Proposed Updates to pittala_3ct_01a_0120

IEEE P802.3cw TF Interim Teleconference Meeting
August 23, 2021

- nicholl_3cw_01a_210809 suggested general updates to pittala_3ct_01a_0120 (see next page)
- This presentation provides detailed changes to the adopted slides in pittala_3ct_01a_0120
- Recommendation:
 - Replace slides 5-9 of pittala_3ct_01a_0120 with slides 5-10 of nicholl_3cw_01a_210823 to enable correlation for the definition of a transmitter quality metric

Fig. 1 Measurement setup for OSNR penalty vs EVM for non-equalizable noise like impairment.

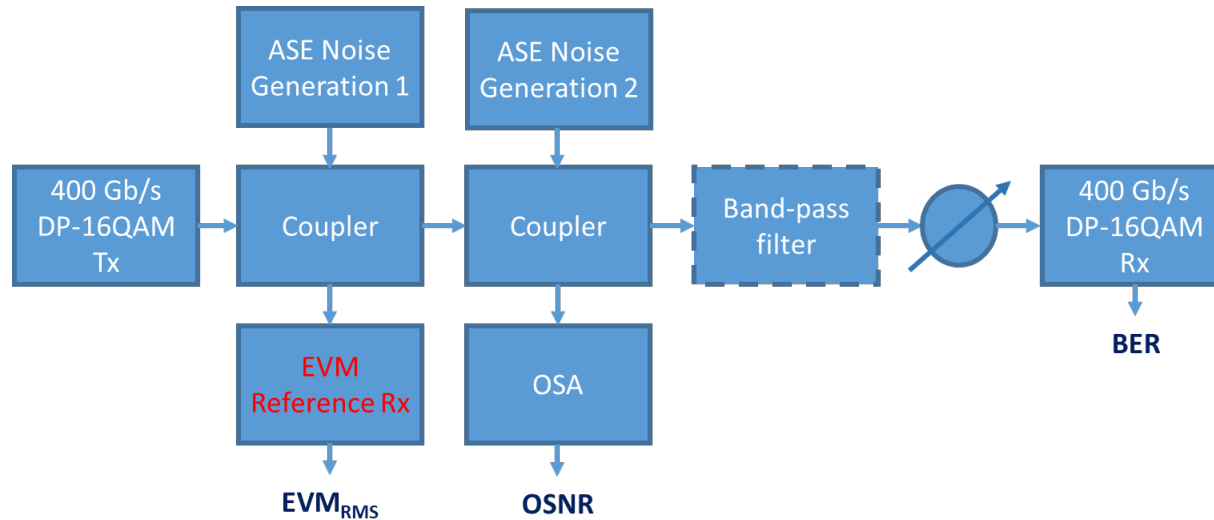
The measurement setup in Fig. 1 (for noise like impairment) and the one in Fig. 2 (for non-equalizable or equalizable impairments) should be used to **test if the following parameters can be covered by EVM:**

Measurements should be taken at a constant optical input power to the DP-16QAM receiver and EVM Reference Rx.

EVM Reference Rx

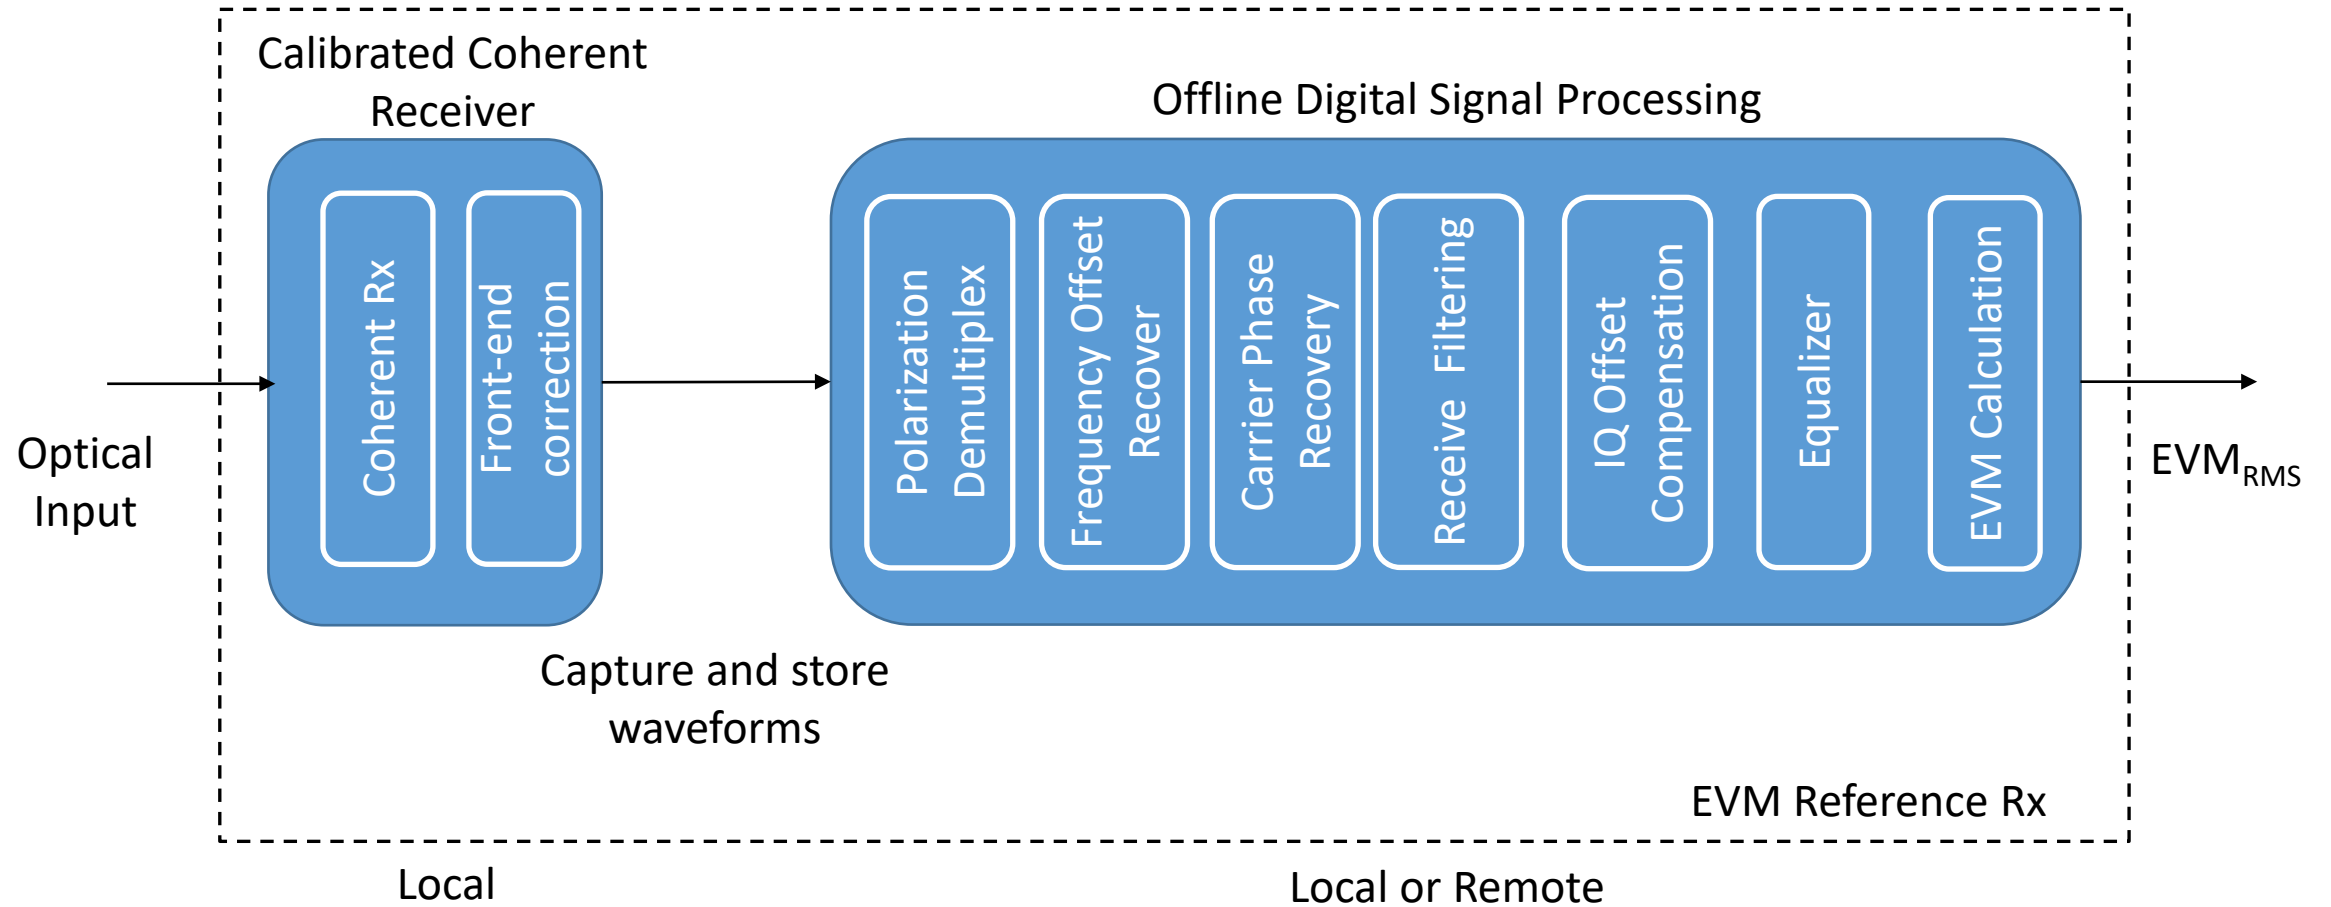
- Calibrated coherent receiver: always “local” to transmitter under test
- Offline digital signal processing: can be either “local” or “remote” to transmitter under test

Measurements based on setup in Fig. 1

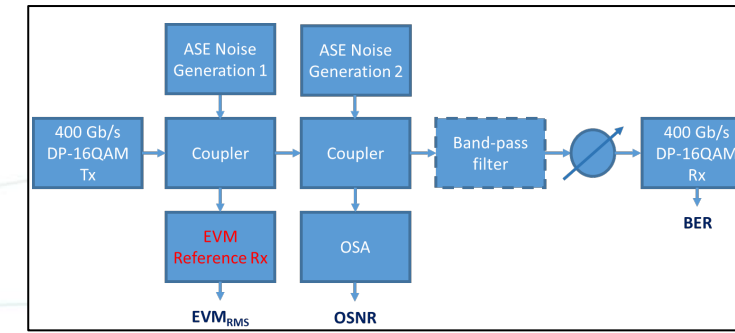
If measuring non-equalizable noise-like impairment using the setup in Fig. 1 the following steps are used:

- 1) Without ASE noise generation 1, adjust the ASE noise generation 2, to get the considered pre-FEC BER of $1.25e-2$; then first EVM_{RMS} and OSNR values are measured (EVM_0 , $OSNR_0$).
- 2) a) Introducing ASE noise generation 1 and measure EVM_{RMS} (EVM_1), the pre-FEC BER is changed (not $1.25e-2$ anymore), b) then adjust the ASE noise generation 2, to set pre-FEC BER at $1.25e-2$ again, then turn-off ASE noise generation 1 and then the second OSNR value is measured ($OSNR_1$), the OSNR penalty is ($OSNR_1 - OSNR_0$).
- 3) Change the ASE noise generation 1, and repeat the step 2), more EVM_{RMS} and OSNR values are measured.
- 4) The curve of OSNR penalty versus EVM_{RMS} is obtained.

Measurements based on setup in Fig. 2

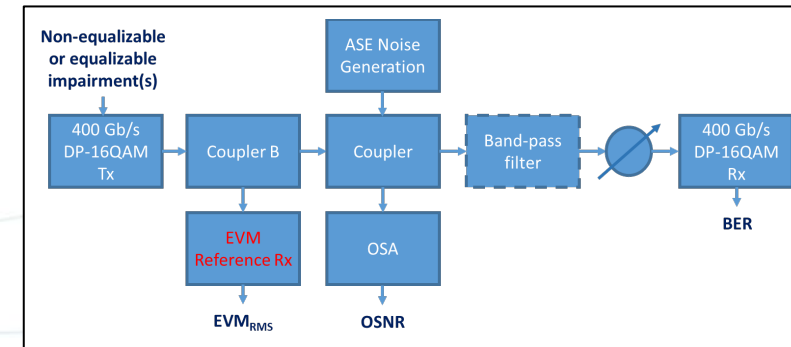
It is preferred that measurements are obtained independently for each parameter, i.e as the effect of varying one parameter is being measured the other parameters remain unchanged.

Using IQ offset as an example the procedure is:

- 1) Adjust the ASE noise generation, to get the considered pre-FEC BER of $1.25e-2$; then first EVM_{RMS} and OSNR values are measured (EVM_0 , $OSNR_0$).
- 2) a) Modify the transmitter to give a certain value of IQ offset and b) measure EVM_{RMS} (EVM_1), the pre-FEC BER is changed (not $1.25e-2$ anymore), then adjust the ASE noise generation, to set pre-FEC BER at $1.25e-2$ again, then the second OSNR value is measured ($OSNR_1$), the OSNR penalty is ($OSNR_1 - OSNR_0$).
- 3) Modify the transmitter to give a certain value of IQ offset and repeat the b) part of step 2), more EVM_{RMS} and OSNR values are measured.
- 4) The curve of OSNR penalty versus EVM_{RMS} is obtained.
